Proposed ConnDOT Maintenance Facility

Willington, Connecticut

Eastern Connecticut Environmental Review Team Report

September 1996

Figure 3

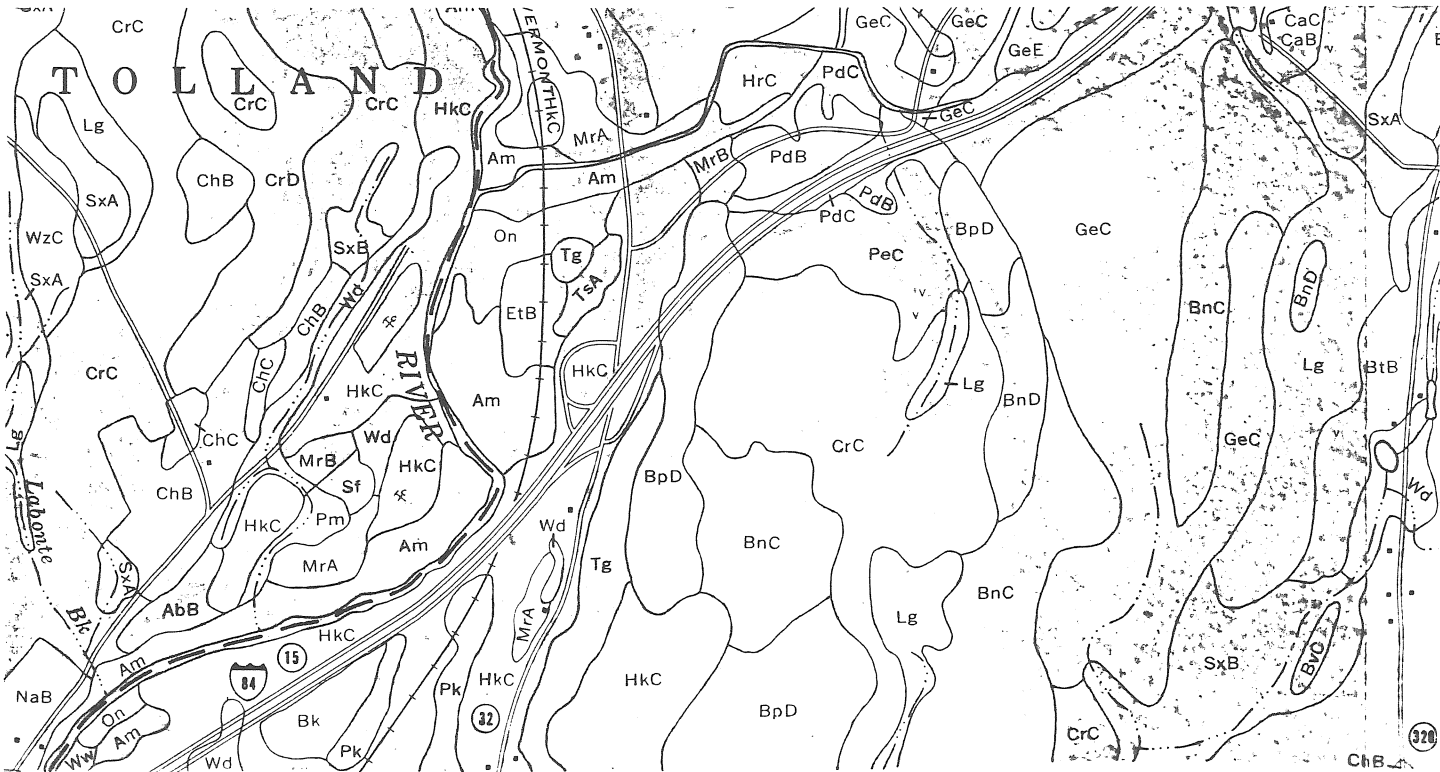
The *Soil Survey of Tolland County, Connecticut* (1966), atlas sheet number 22, indicates those soil map units found to exist on this site (Figure 3). An update of the soil survey is in progress and interim mapping has been completed for this area. Changes to the atlas sheet number 22 for this site is shown on Figure 4, "Proposed Willington MTCE Facility Site", prepared from CT DEP/NRCS digitized soil mapping presented by Christopher Malik, Transpiration Planner, CT-DOT. The digitized map represents changes to the official soil map of the 1966 Soil Survey. This remapping was completed prior to the placement of fill materials in the mid 1990's. Field investigation by the USDA-Natural Resources Conservation Service (NRCS) confirm the recent remapping and concur that it should be used as the official soils map for pre-fill conditions. Any new mapping completed should show an extension of the map unit 306 (Udorthents) into the map unit 57B (Gloucester gravely sandy loam) which would represent the filled area.

Figure 4

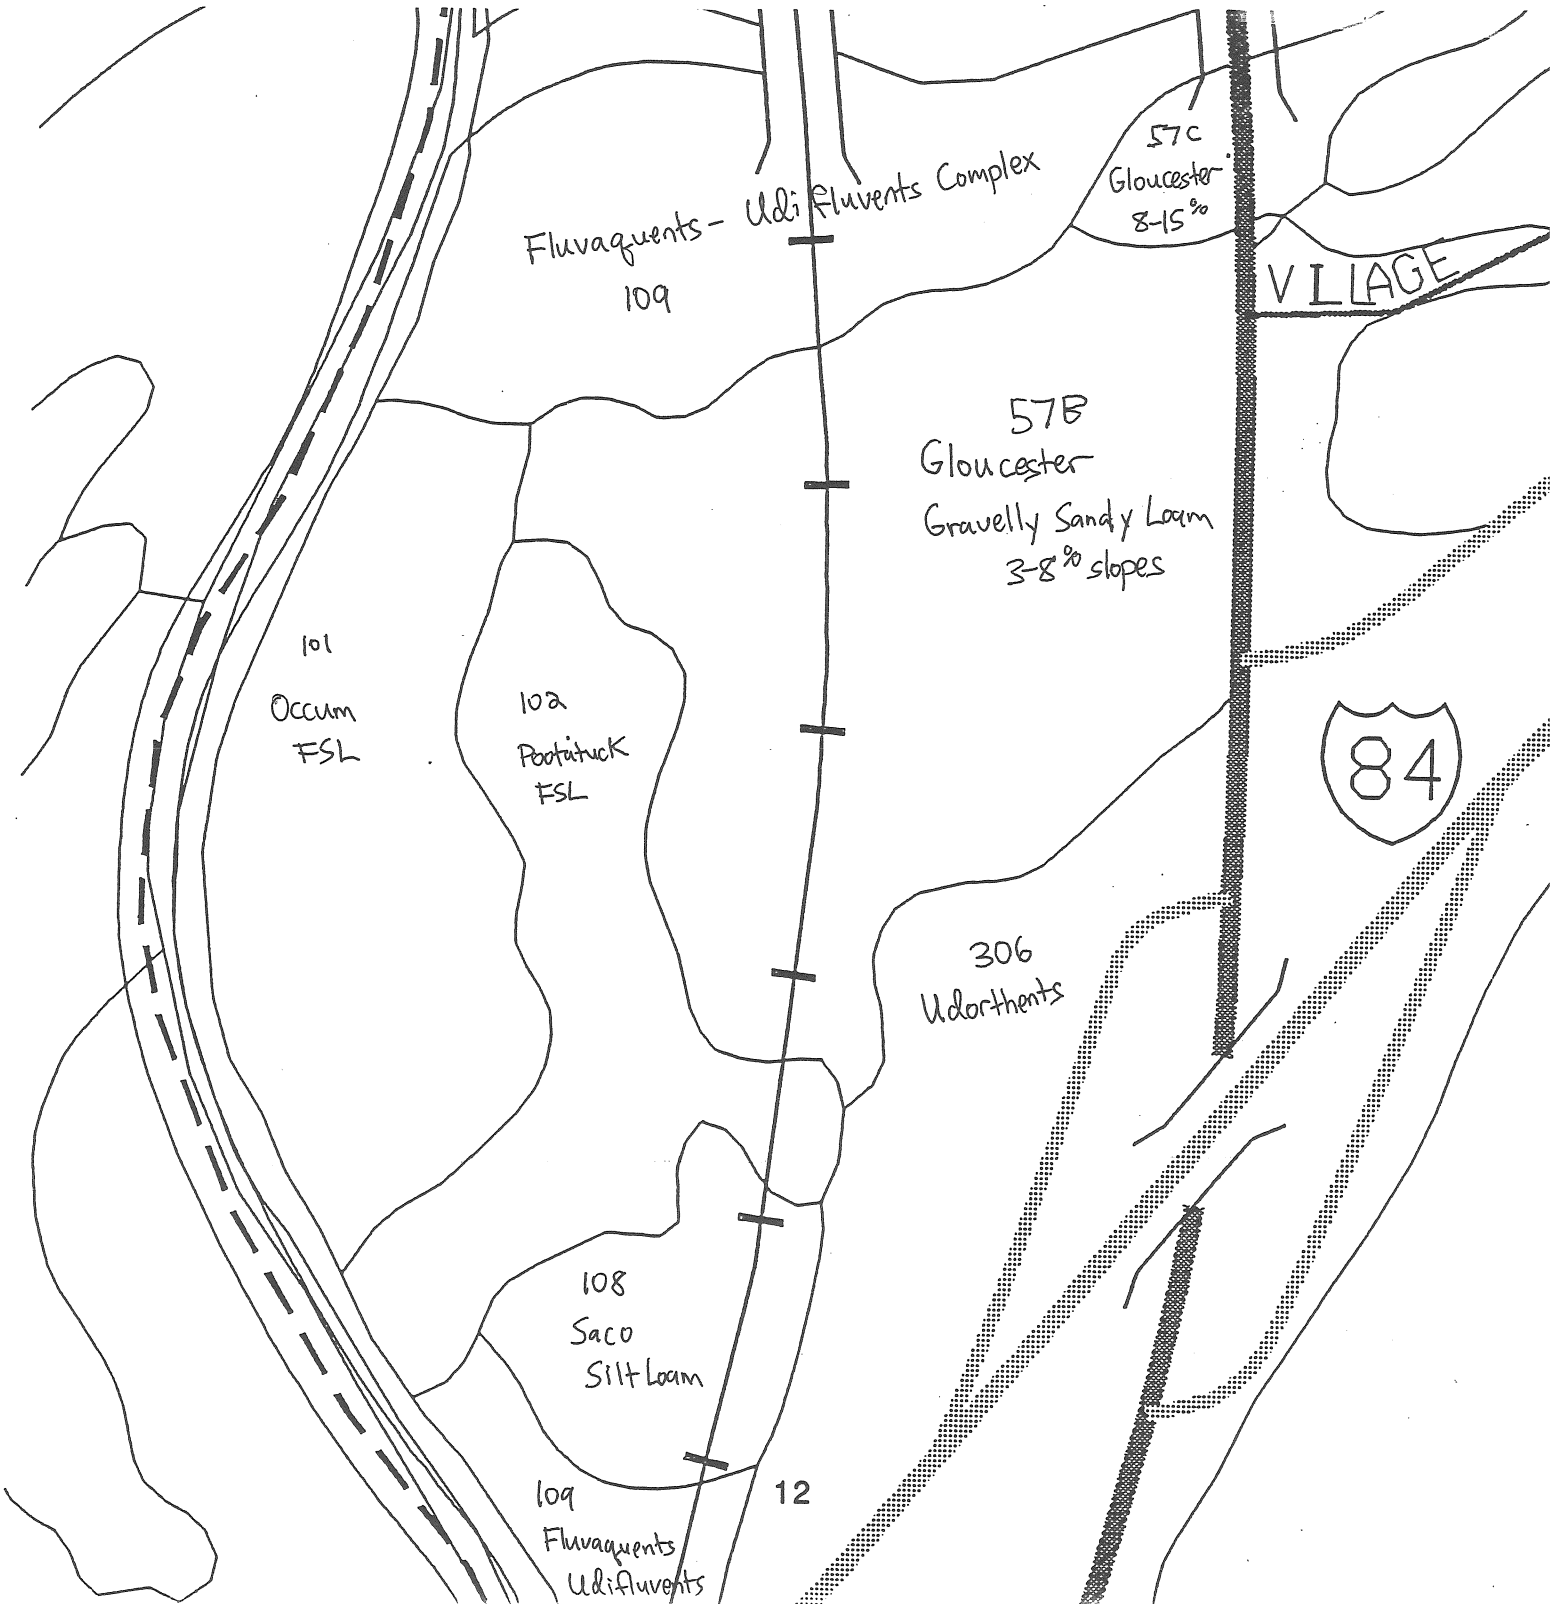
In using the attached soil reports, the reviewer should use the soil map unit and description OnA for the unit-101 (Occum fine sandy loam), PoA for unit 102 (Pootatuck fine sandy loam), GcA for units 57B and 57C (Gloucester sandy loam), SbA for unit 108 (Saco silt loam), Am for unit 109 (Fluvaquents-Unifluvents Complex) and Ma for unit 306 (Udorthents).

Figure 7

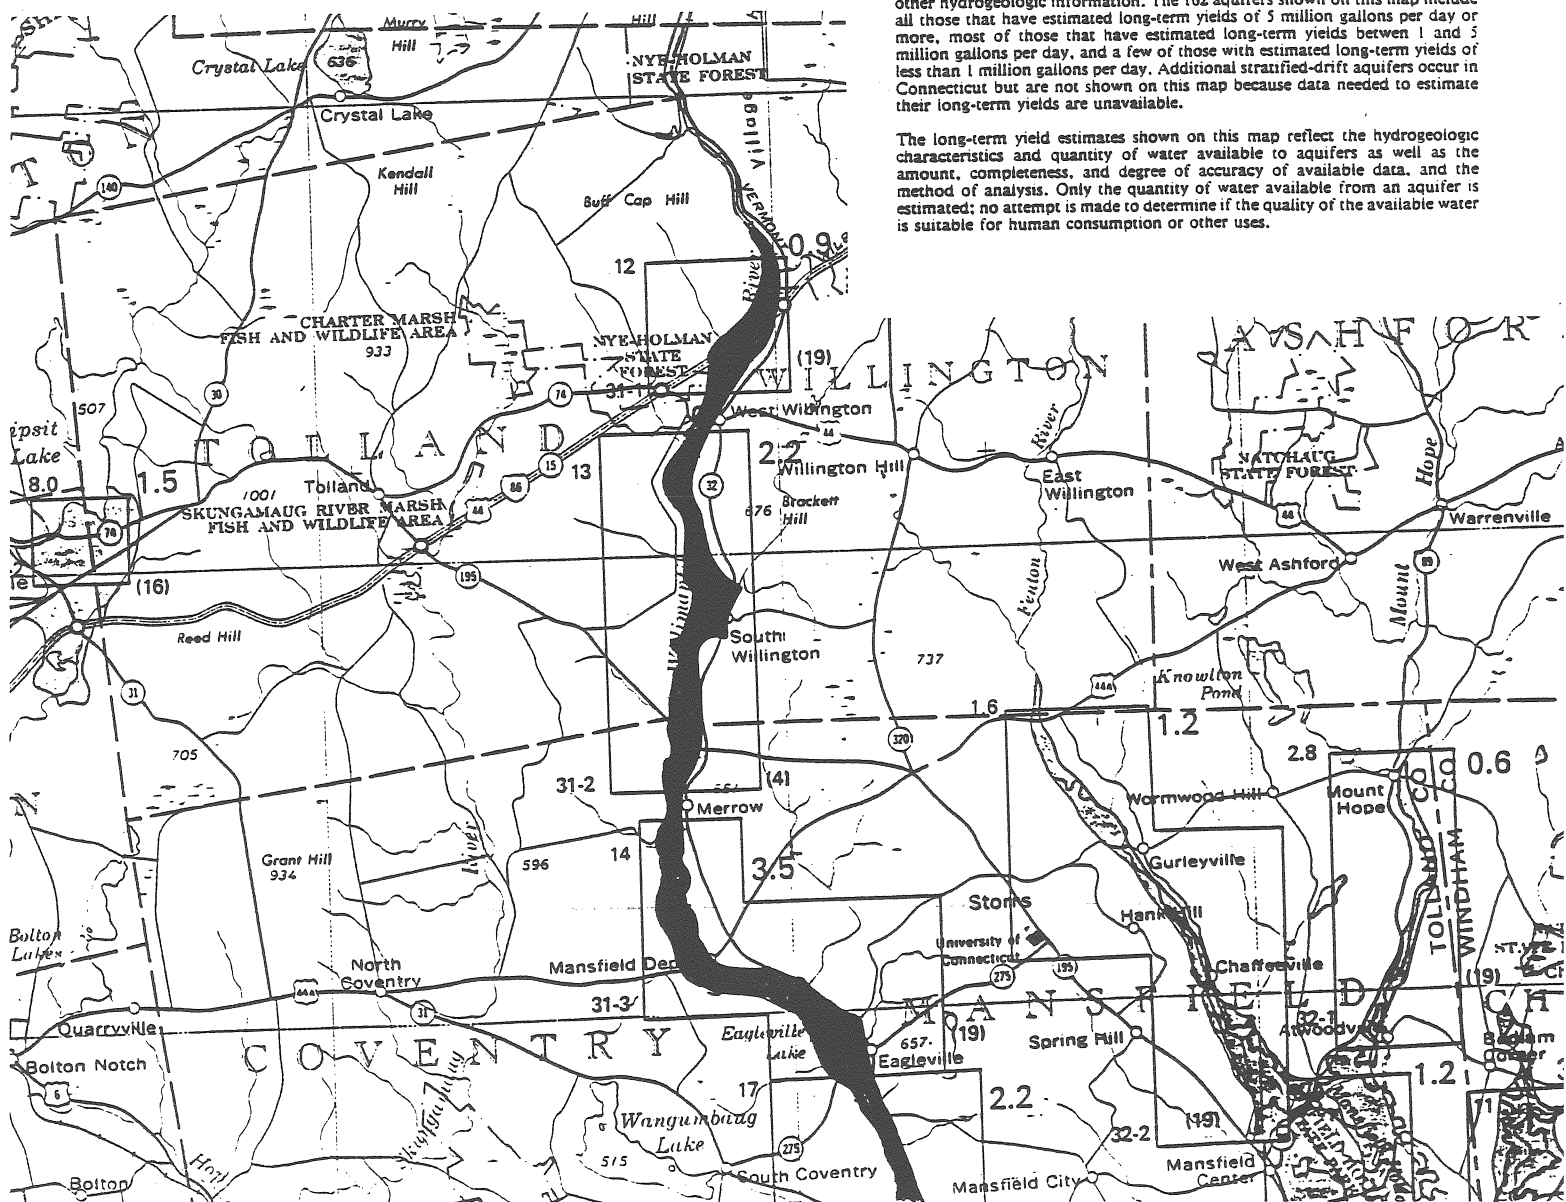
The site is located at the outlet of the Roaring Brook watershed where it enters the Willimantic River. Roaring Brook drains approximately 21.6 square miles of watershed in four towns. The Willimantic River is a regional drainage basin of 225 square miles, ranging from Massachusetts to Willimantic. The site is located in the upper middle part of the basin (see Figures 5 & 6 for the drainage basin map and site location). Although the site topography has been altered with fill, the surface drainage pattern is to the north and west entering a wetland and overflow (secondary) channel of Roaring Brook which flows to the Willimantic River. The site is located on a large stratified drift deposit which parallels the Willimantic River valley. A stratified drift aquifer underlies the site south to Coventry. According to the state groundwater mapping, the aquifer is known or inferred to be capable of yielding moderate to very large amounts of water. Groundwater flow at the site would generally be in the west direction toward the Willimantic River (see Figure 7).

Figure 8

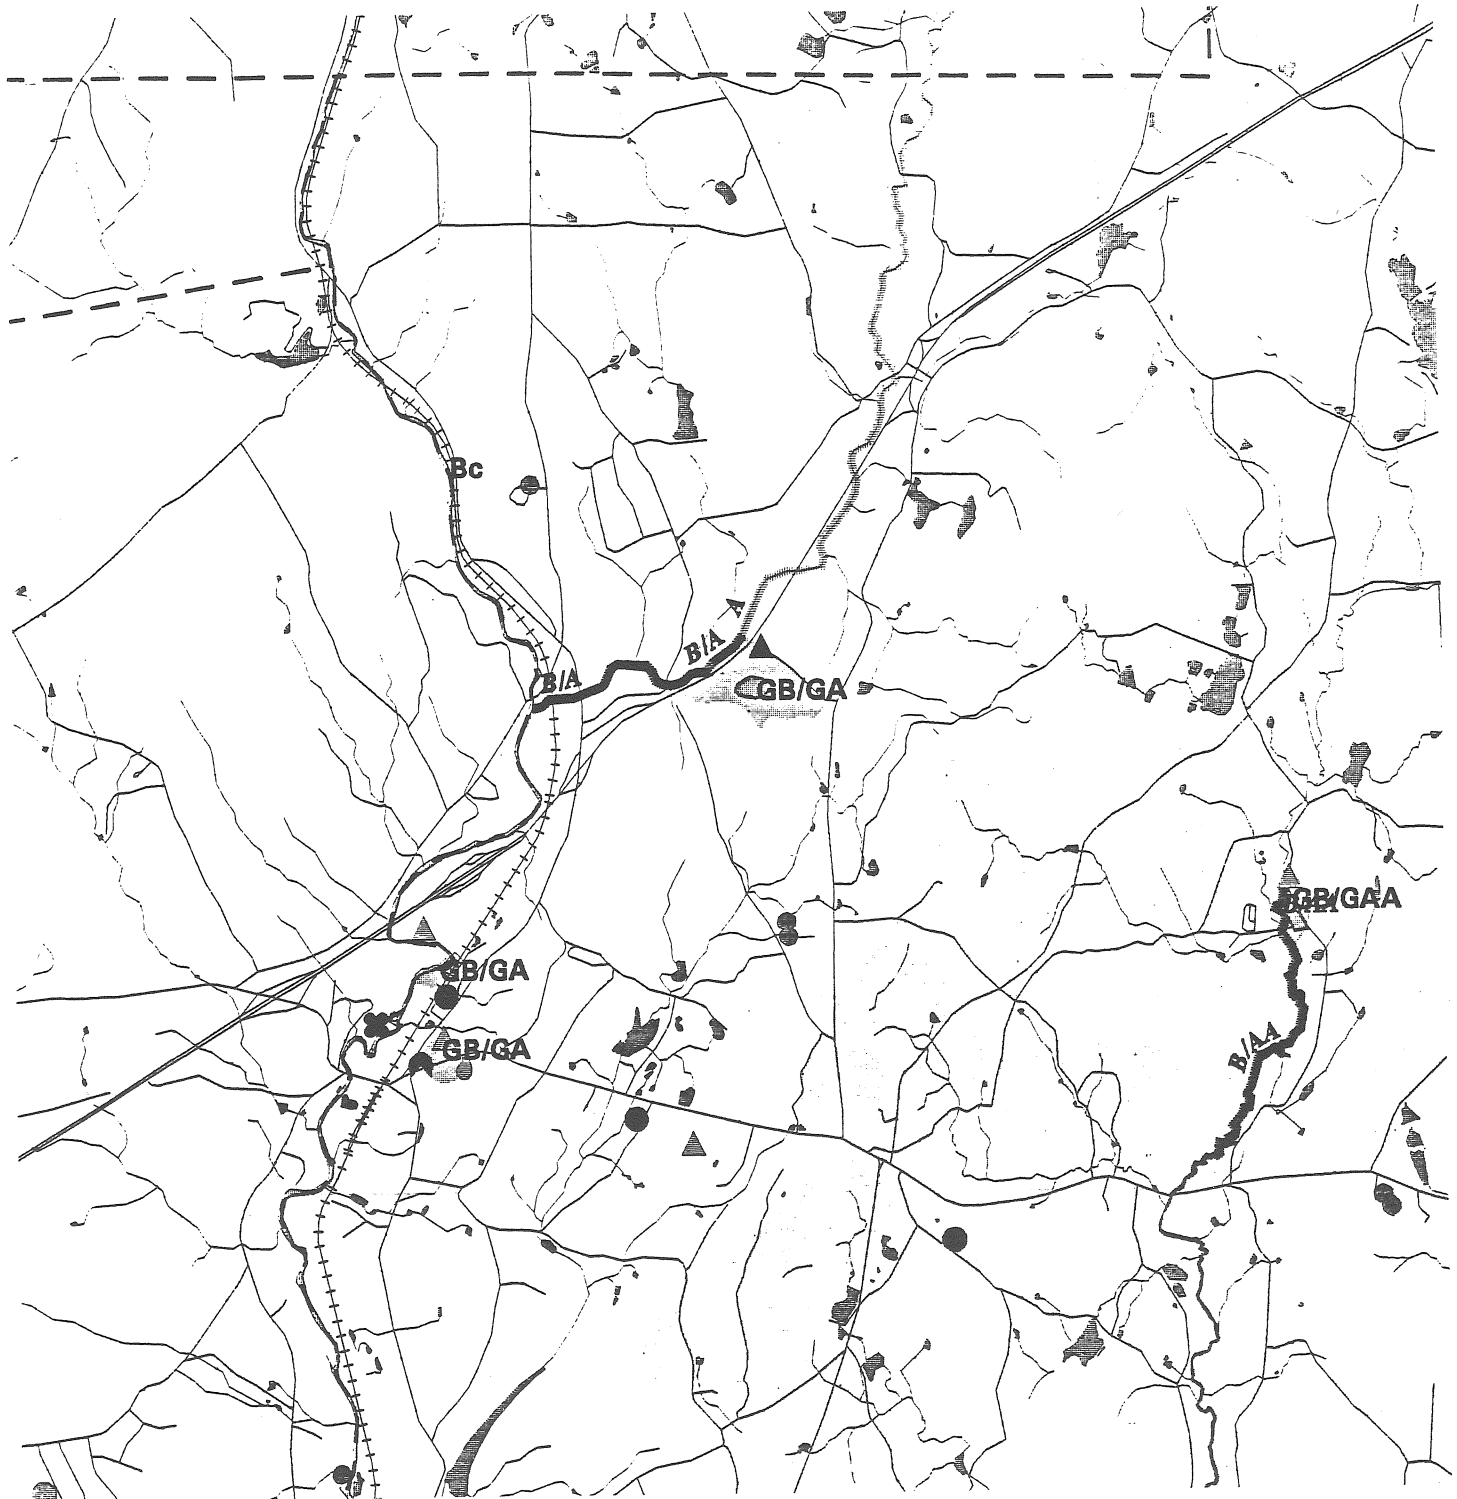
DEP classifies water quality conditions and sets goals for all surface and groundwater resources based on designated use and the State Water Quality Standards. The Standards and Classifications are designated to manage water quality to protect health, the environment, and legitimate uses of water resources. The lower segment of Roaring Brook is classified B/A water quality, B is the existing condition and A is the goal. The "A" quality designates use of the brook as potential drinking water supply, fish and wildlife habitat, recreation, agricultural, industrial supply and other legitimate uses. The existing "B" quality condition indicates it may not be meeting the water quality criteria for one or more designated uses. Potential sources of impairment includes the Willington mixed waste landfill about one (1) mile upstream. The Willimantic River is classified "B" water quality and designated for all uses above except potential water supply. Treated waste water discharges are not allowed in Class A waters but may be allowed in Class B subject to state discharge permitting requirements (see Figure 8).
